Bill No. 01R-29

TITLE: **SPECIAL PERMIT NO. 1869, KNIGHTS COURT COMMUNITY UNIT PLAN**, requested by Ross Engineering, Inc., on behalf of Council Building Association, for 25 dwelling units, on property generally located at 5900 South Street.

LINCOLN CITY/LANCASTER COUNTY PLANNING STAFF REPORT

P.A.S.#: Knights Court C.U.P. **DATE:** January 1, 2001
Preliminary Plat #00024
Special Permit #1869

Sheet: 3 of 3

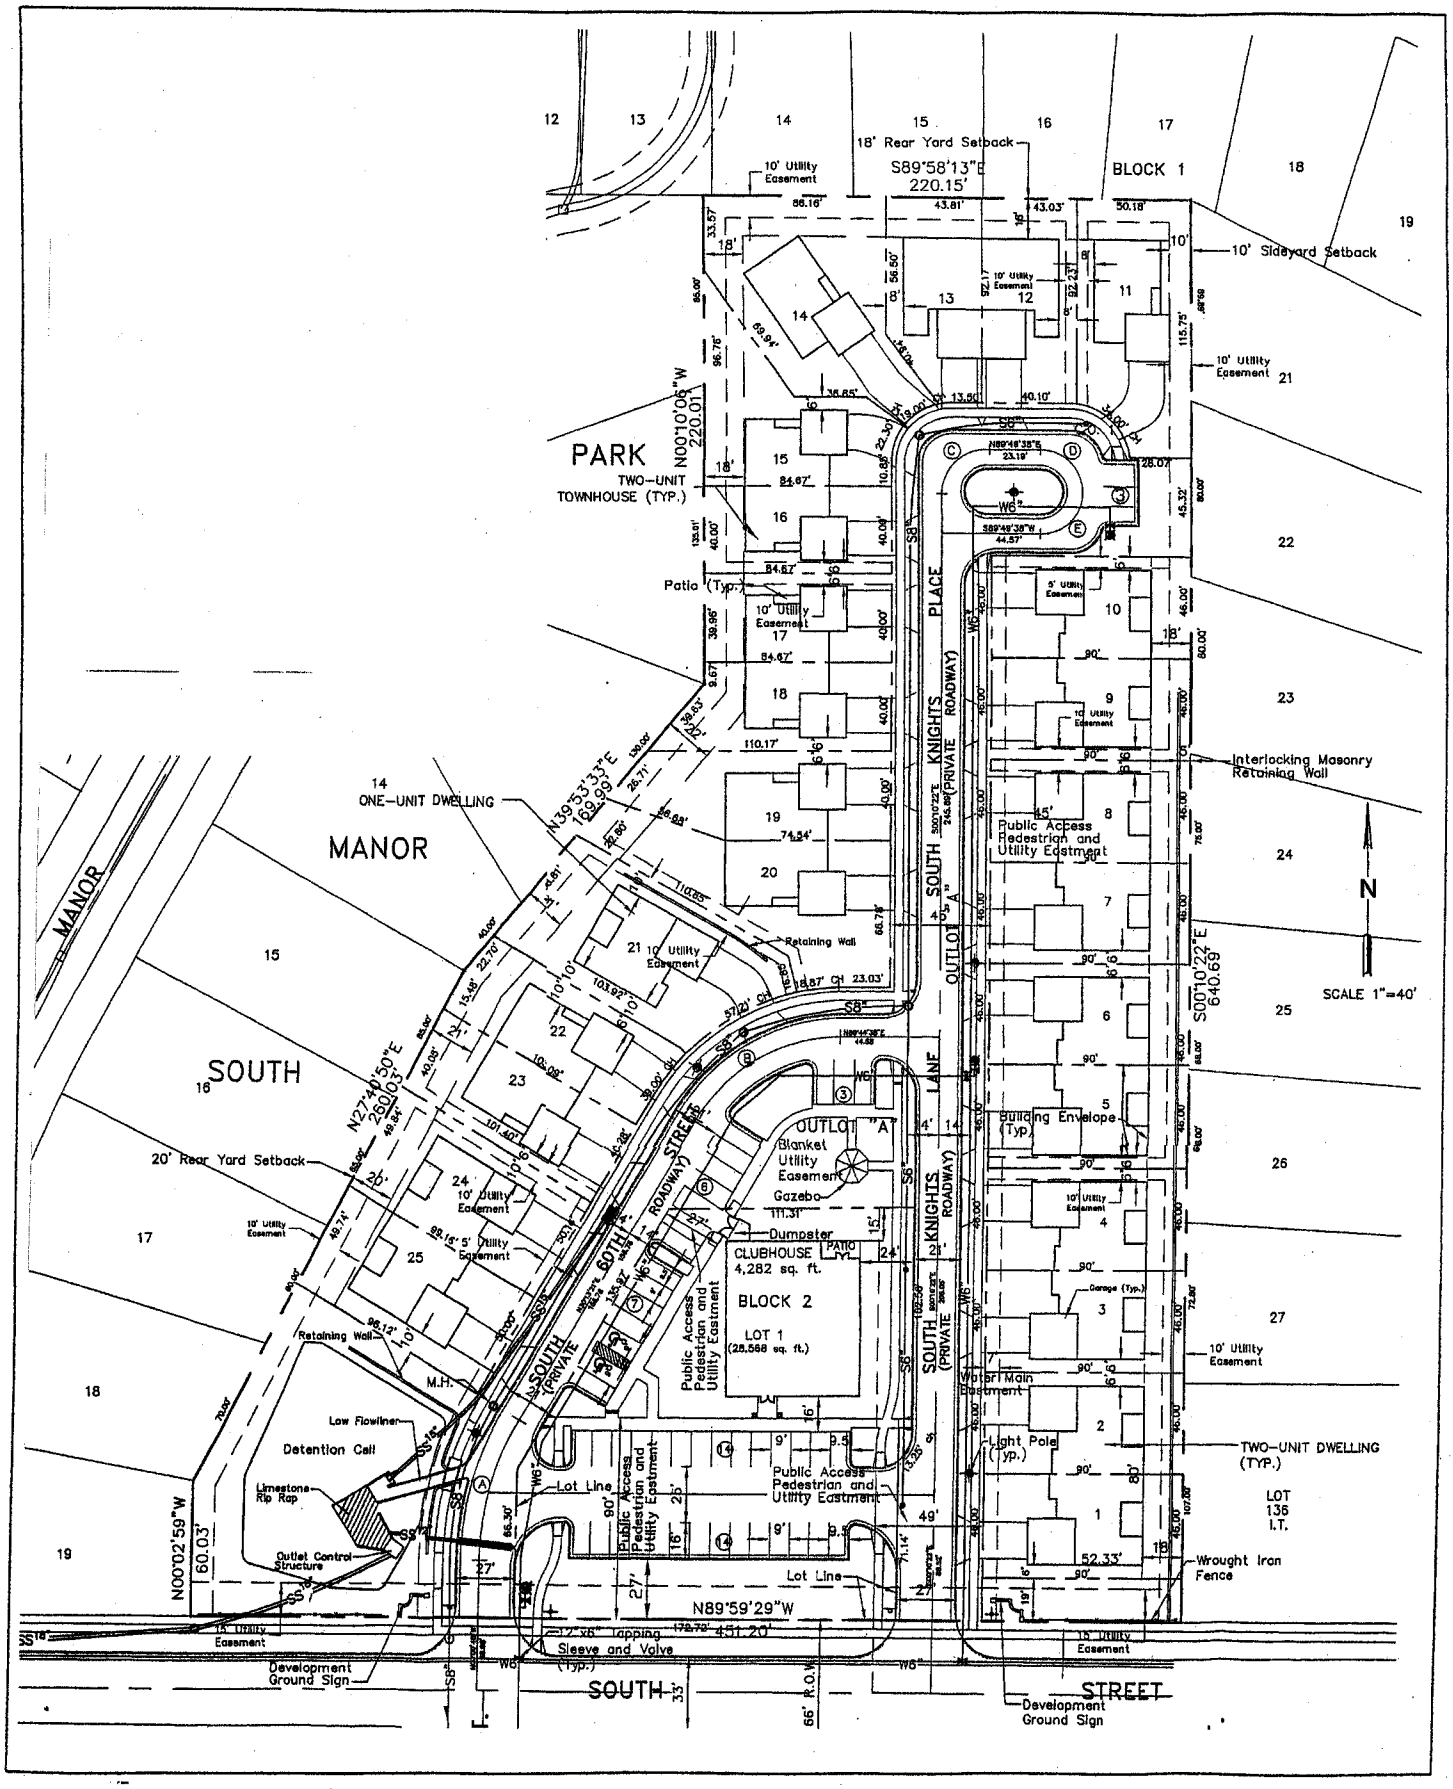
1.1.11 ~~10 foot side yard setback on the lots with two family housing and 20 foot rear yard setback on all units.~~ Rear yard setback shall be no less than 18 feet and side yard setback shall be no less than 5 feet. **(**Per Planning Commission, 01/10/01**)**

1.1.3 In Note 8, delete "Decks and/or patios may be covered no less than 15 feet from the rear lot line."

1.1.5 Dimension front yard setbacks

1.1.6 Clearly identify the 45' public access, pedestrian and utility easement shown on lot 8

1.1.7 Dimension the side yard in lot 20

1.1.8 In Note 17, replace "National" with "North"

1.1.9 In Note 1, delete the comma between "Outlot;" and "including", and delete the sentence describing the allowable density

1.1.11 Add sidewalk ramps to the east-west sidewalks that intersect S. 60th St. and S. Knights Lane, and remove the sidewalk lines from the street

1.1.12 In the Landscape Plan notes, replace "is intended to" with "shall"
